**Helotes Creek Gravity Main and Lift Station #246 Elimination Project  
(RFCSP)**

**Solicitation Number: CO-00563**

**Job No.: 16-4403**

**ADDENDUM 2**

### SEGMENT 1 - 18" PVC SANITARY SEWER LINE A

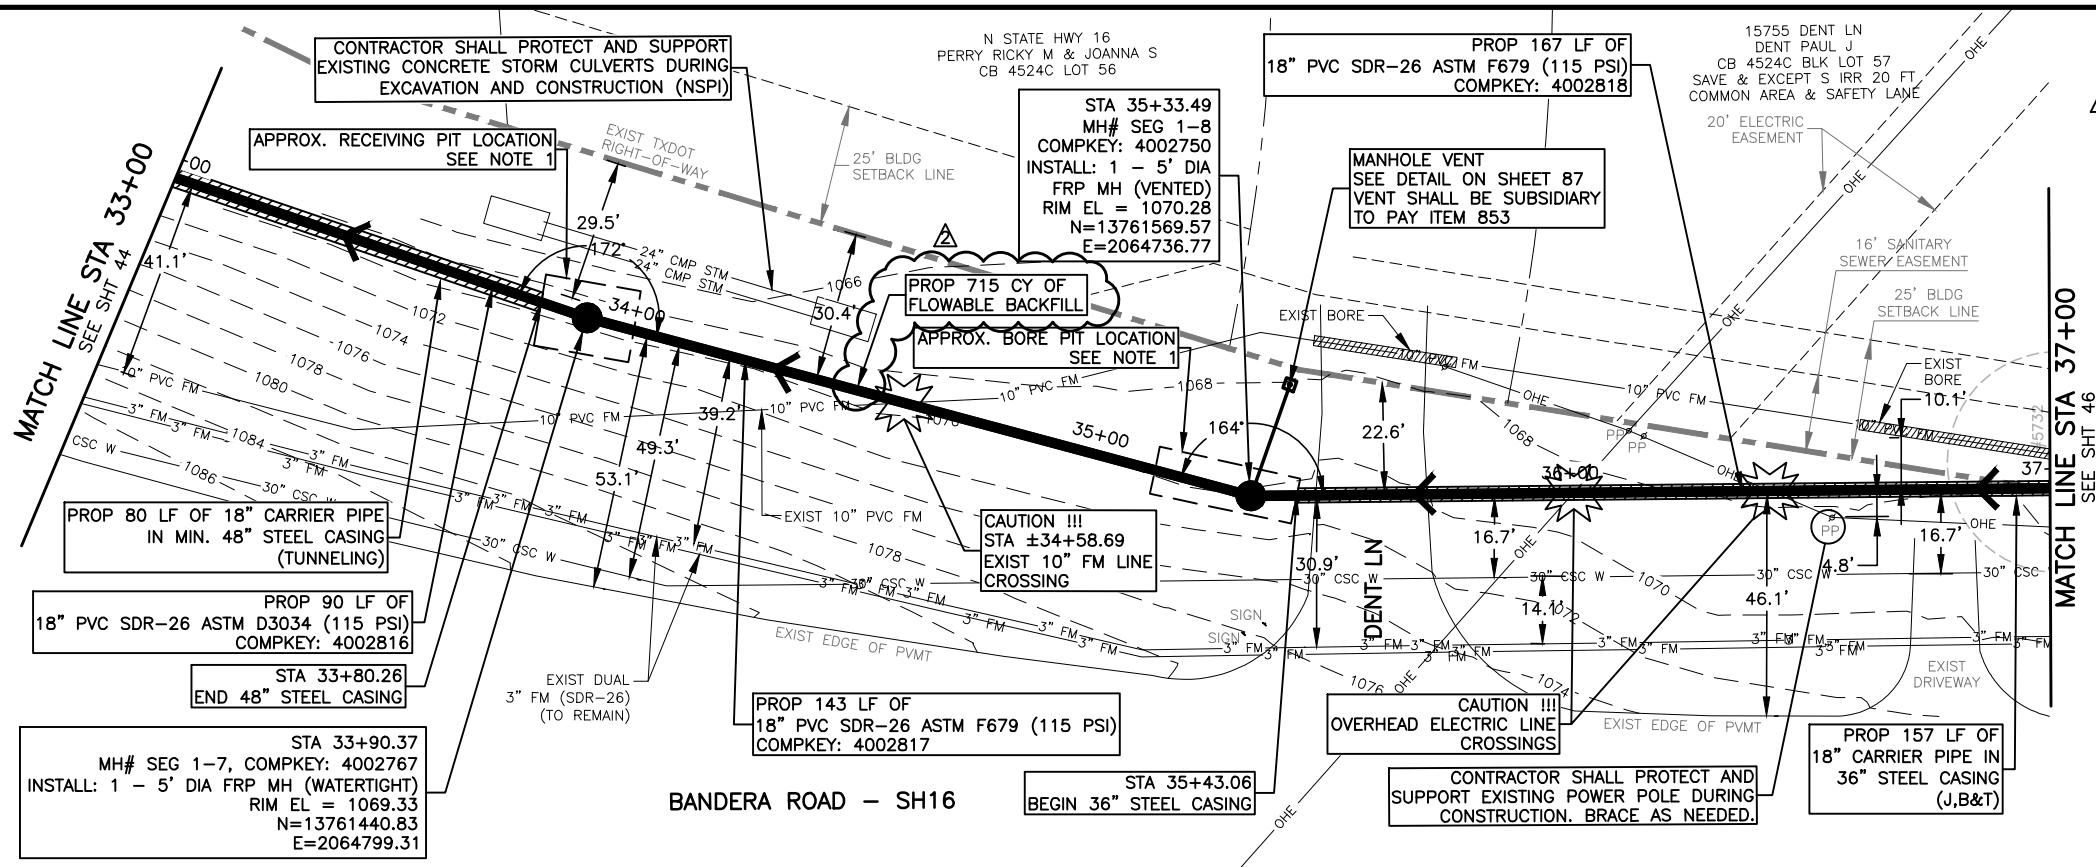
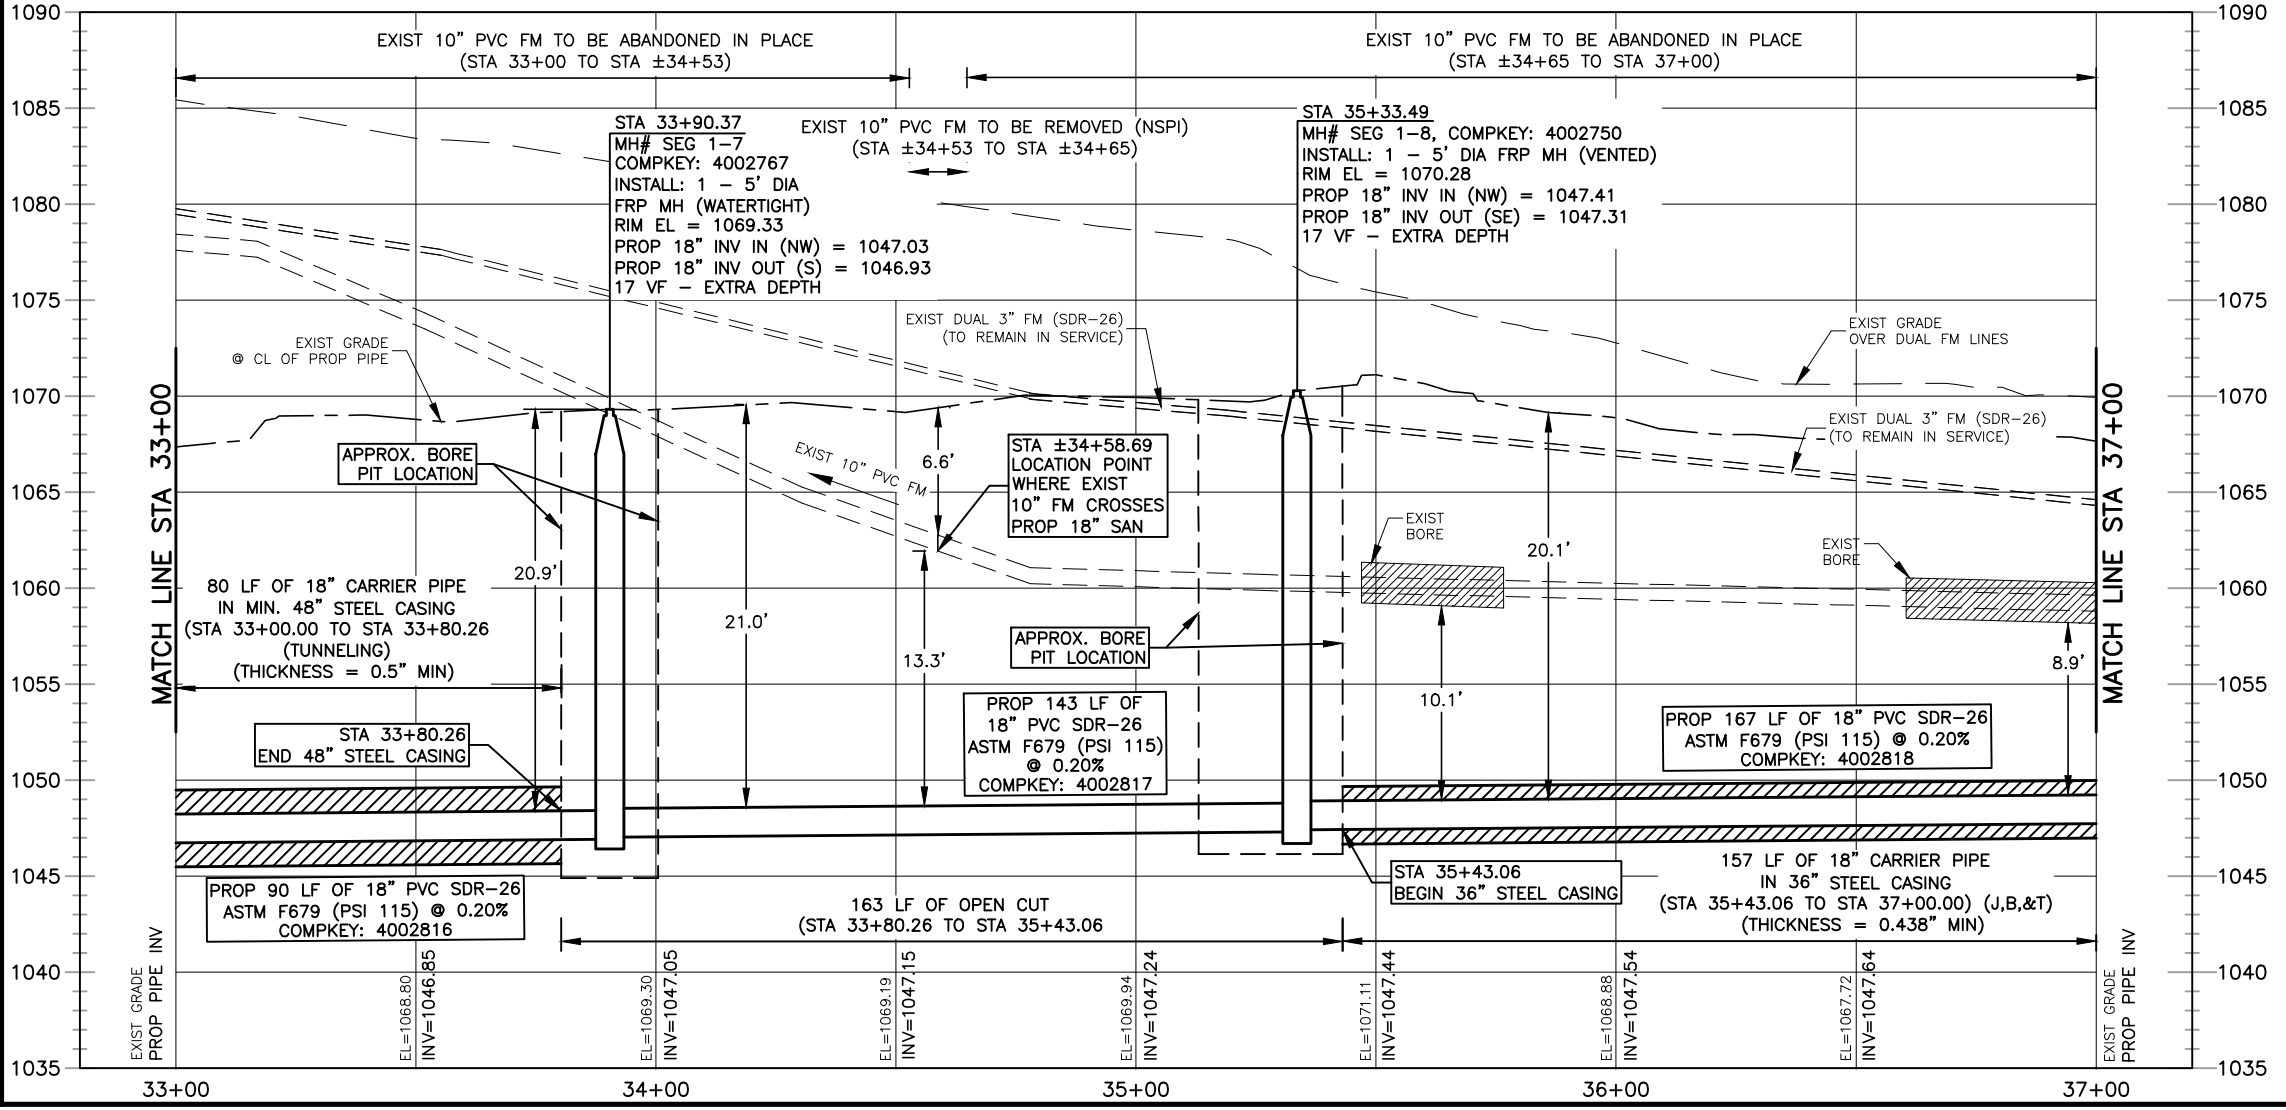
4. Delete Sheet 45 of 103 of the plans in its entirety and replace with the attached Sheet 45 of 103, dated 8/1/22. Sheet 45 has been revised to add Item 401 – Flowable Backfill (TxDOT Spec).
